NFPA 780

2008 Edition

ULPA/LPI Annual Conference

Zone of Protection

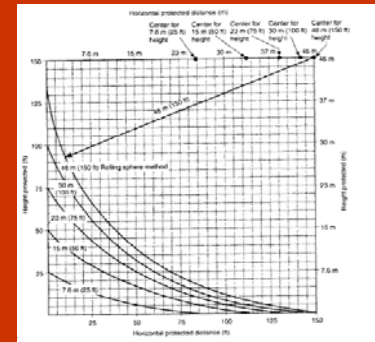
- Wording is changed in various paragraphs from Rolling Sphere **Model** to Rolling sphere **Method**.

- The formula terms are changed to use the value **R = rolling sphere radius** (150 ft. or 46m for ordinary structures) – So the formula now reads:

$$d = \sqrt{h_1(2R - h_1)} - \sqrt{h_2(2R - h_2)}$$

Strike Termination

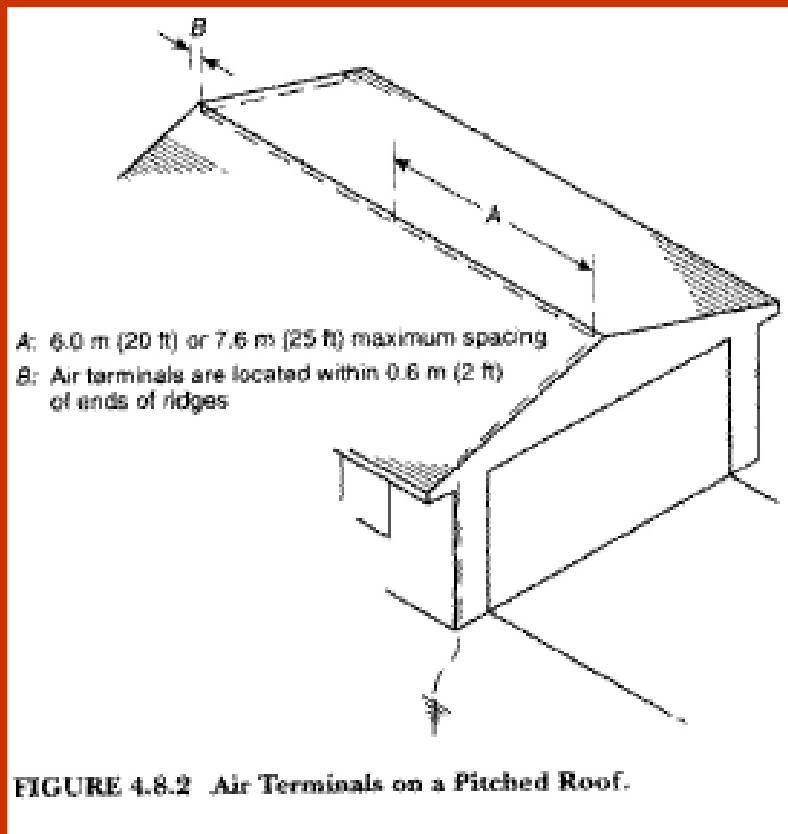
- 4.8.2 – Location of Devices. As shown in Figure 4.8.2, the distance between strike termination devices and ridge ends on pitched roofs, or edges and outside corners of flat or gently sloping roofs, **shall not exceed** 0.6m (2 ft.). (replaces - at or within)

Strike Termination

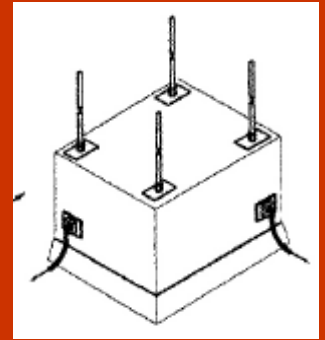
- **NEW 4.8.9 – Metal Roof Top Units.** Roof top mechanical units with continuous metal housings less than 4.8 mm (3/16 in.) thick such as air conditioning / heating units, metal air intake / exhaust housings, cooling towers, and so forth, shall be protected by 4.8.9.1 through 4.8.9.2.2.
- 4.8.9.1 Air terminals shall be installed in accordance with 4.8.1 and 4.8.2.
- 4.8.9.1.1 These air terminals shall be mounted on bases having a minimum contact area of 1940 mm² (3 in.²) each secured to bare metal of the housing or mounted by drilling and tapping to the unit's frame per 4.16.3.2 and 4.16.3.3.

4.9.3 Substitution of Main Conductors

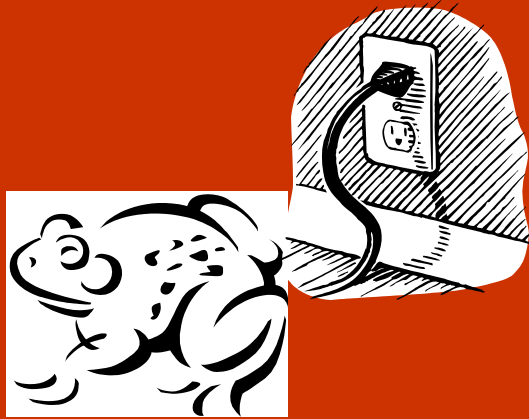
4.9.3.1 Ancillary metal parts of a structure, such as eave troughs, downspouts, ladders, chutes, or other metal parts **except as permitted in 4.16.1** shall not be substituted for the main conductor.

4.9.3.2 – Permanent exterior metal handrails and ladders that are **subject to direct lightning strikes (e.g., on roofs or between roofs)** and are electrically continuous shall be permitted to be used as main conductors where the minimum thickness is 1.63 mm (0.064 in.)

Grounding

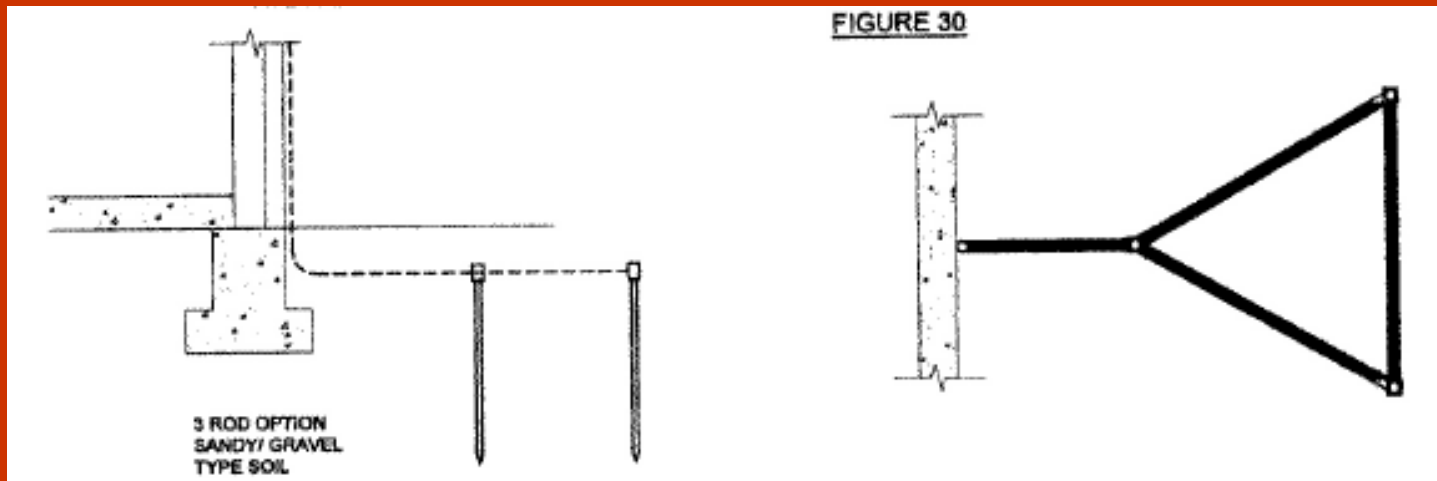
- Par. 4.13.2.4 Multiple Ground Rods. Where multiple connected ground rods are used, the separation between any two ground rods shall be at least the sum of their **driven depths** where practicable. (replaces “lengths”)

FIGURE B.3.2.2 Lightning Protection Design Using the Rolling Sphere Method.

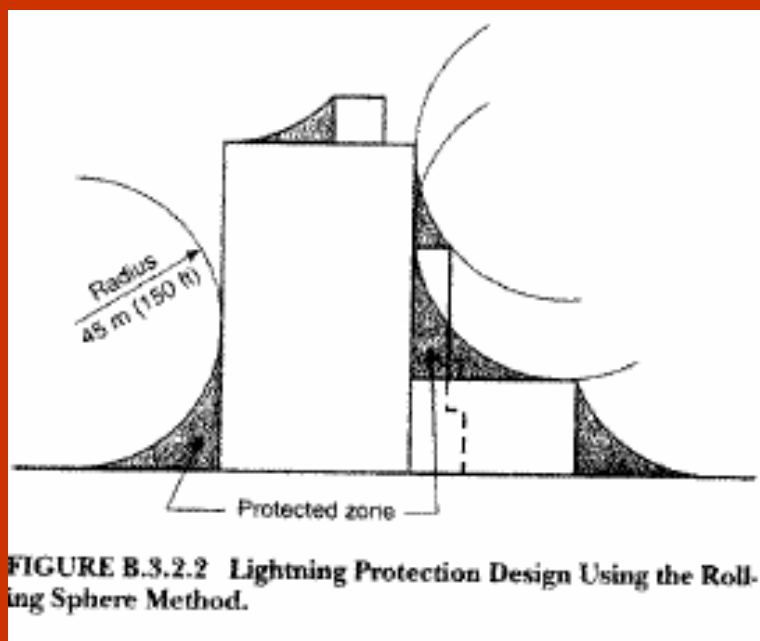
- Principles of Lightning Protection
- **B.2 Lightning Protection Systems**. There is a new series of paragraphs discussing the physics of lightning attachment, and how cone of protection and the rolling sphere method are derived technically.
